Serial No. 40/801,307

**REMARKS**

**Objections to the Drawings**

Annotated Sheet  
Application No. 10/801,307  
Art Unit: 3752

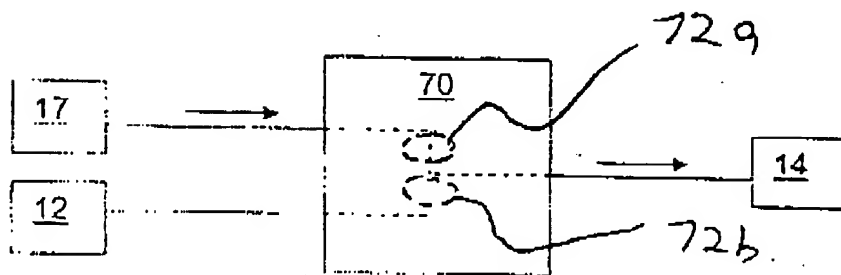
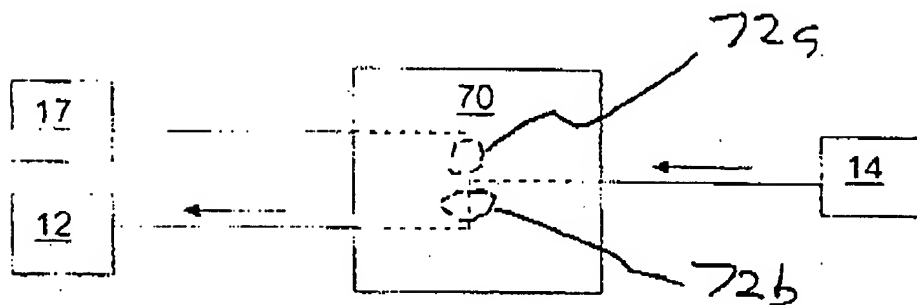
Figs. 11A-11C have been amended to schematically illustrate the two valve seats as requested in the Office Action. New drawing sheets are attached. The drawings are a schematic depiction of what is described in the specification. No new matter is added.

The drawings continue to be objected to by the Examiner. Examiner now states that not only the first position, second position and default neutral positions, but also the two valve seats, must be shown in the drawings or cancelled from the claims.

Responsive to this objection, applicants hereby submit corrected drawings, which now show schematically show these features.
